To: T10 Technical Committee
From: SDV working group via Bill Ham (Bill.Ham@Compaq.com)
and Rob Elliott, Compaq Computer Corporation (Robert.Elliott@compaq.com)
Date: 11 September 2001
Subject: T10/01-149r3 SDV working group recommendations for changes to SPI-4

This document contains the recommendations of the SDV working group for changes to SPI-4 regarding the margin control mode page and ECP page and to define "driver-receiver connection" in the model.

Figure 1 - Device to device driver-receiver connections

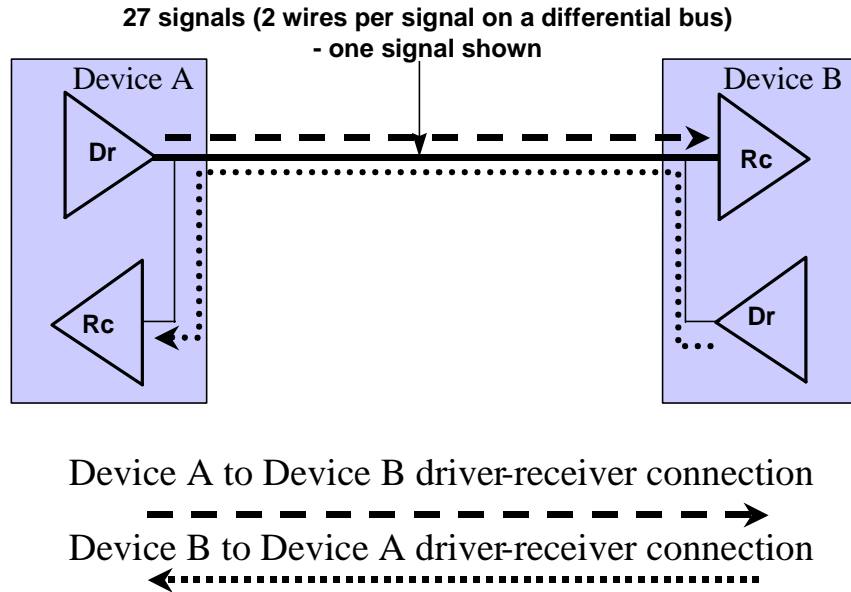
[add this text as a new section:]

Figure 1 shows a portion of a single SCSI bus segment between two SCSI devices. Each device has a driver and a receiver for each signal. There may be other SCSI devices or terminators not shown in Figure 1 that are connected to the path between the driver and the receiver. Two driver-receiver connections exist between any two SCSI devices or simple expanders, one for each direction.
